**COMMENTS ON APPLICATION REFERENCE 2015/5353/P
Great Ormond Street Hospital, Great Ormond Street, London, WC1N 3JH**

Installation of 4 chiller units at roof level of Variety Club Building (East and West roofs) with associated screening and pipework.

To: Carl Standley (CPW)
From: Vernon Cole
Project: UCLH Review of GOSH Rooftop Chiller Application
Subject: Plant Noise Assessment
Reference: 25/0650/M1
Date: 29 October 2015

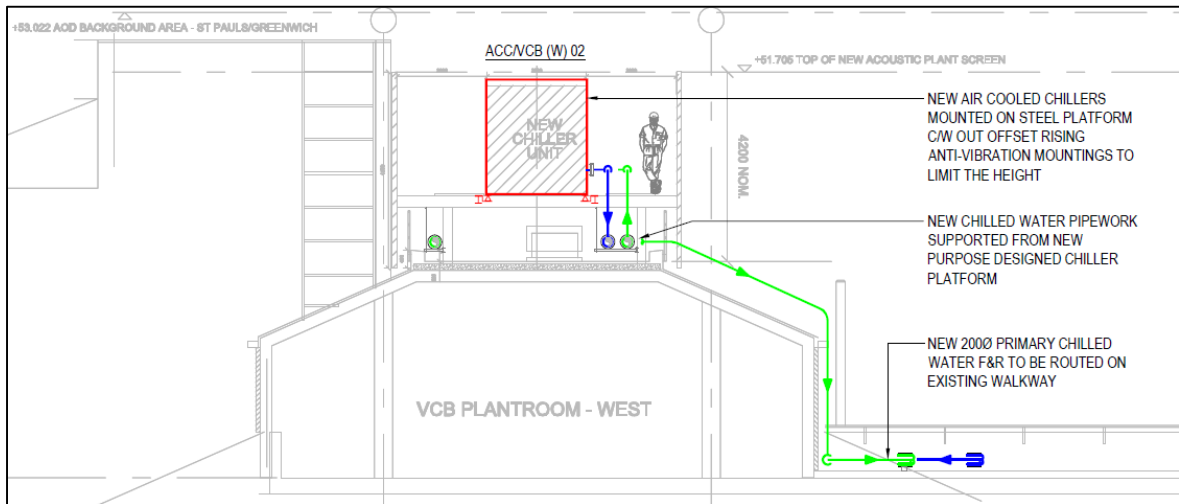
3.1.3 In order to mitigate noise emission from the proposed new plant, it is proposed to install an acoustic screen on the west, north and east sides of each plant compound. The screen is specified to be constructed using solid barriers with a mass of not less than 20kg/m² and an absorptive surface facing inward toward the plant. The location and size of the screen is indicated in TBA drawing LA5566-M-51-RR-001 Revision R01, which is contained in the BDP report, an excerpt from which is shown below:

For the western plant compound, which is of interest with regard to noise emission to the NHNN, it can be seen that the screen extends in height to the top of the chillers and is located 2m from the sides of the chillers. It should be noted that a significant noise source in the chillers is the fans, which are located on the top panel.

3.1.4 BDP identify the proposed screens as being capable of attenuating noise from chillers by 14dB, thereby reducing the predicted plant noise levels to 43dBA, exactly equivalent to the proposed noise standard. It should be noted that no details are provided in the report of the geometry of

the source/receiver/barrier arrangement so the precise path difference values that have been used in the BDP analysis cannot be determined.

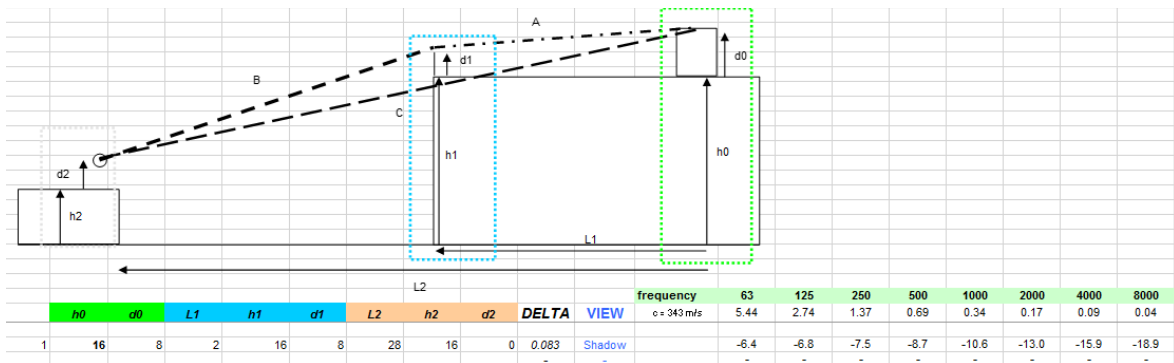
3.2.1 We do not have the benefit of scaled drawings showing the plan and section of the proposed plant installation in relation to the 4th floor NHNN ward windows. However, based on the drawn information in the BDP report and scaling off heights and distances using Google Earth Pro, the following are considered to be the relevant dimensions for the analysis of plant noise emission and screening effects:

- Horizontal distance NHNN ward windows to chiller plant: 28m
- Vertical distance top of NHNN ward windows to top of chiller plant: 8m
- Vertical distance top screen to top of NHNN ward windows: 8m
- Horizontal distance screen to chiller plant: 2m

3.2.6 Effectively, the screening is limited by the fact that the significant noise sources on the chillers, the fans, are located at the same height as the top of the screen. Therefore, while the screening

is effective at removing the line of site from the 4th floor windows in the NHNN building, but it does not provide a deep shadow zone which is required for optimum effectiveness.

Project Name UCLH
Project Reference 15/0650
Receiver Reference AP1
Description Hospital
Noise Limit 43
dB(A) 58

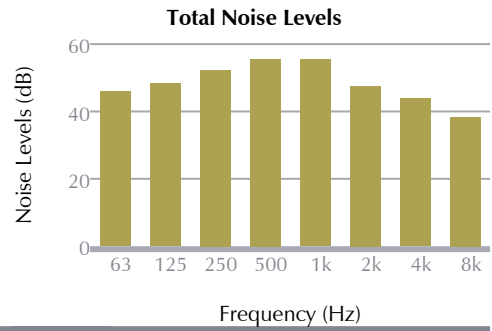
3.2.2 For the unscreened condition, calculations of the expected noise levels are set out in attached Calculation sheets CS1 to CS5. It can be seen that taking the plant noise level data as set out in the BDP report, and allowing for some directivity effects for noise radiated by the fans on the top of the chillers, we predict façade incident noise levels at the nearest NHNN windows of 58dBA, 1dB higher than the values determined by BDP. This degree of difference is not considered material.

3.2.3 Considering the summary contained in CS5, it is clear that the noise levels at the receptor are dominated by the air cooled chillers, as indicated in the BDP assessment.

Project Name UCHL
Project Reference 15/0650
Receiver Reference AP1
Description Hospital
Noise Limit 43
dB(A) 48

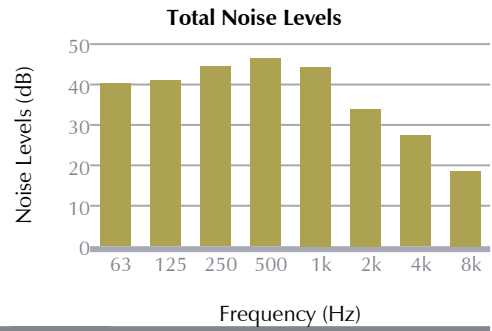
3.2.4 For the unscreened condition, calculations of the expected noise levels are set out in attached Calculation sheets CS6 to CS10. Our calculations indicate that the screen is not expected to be as effective in reducing noise emission as allowed for in the BDP assessment, giving a resulting overall noise level of 48dBA, some 5dB above the relevant design standard.
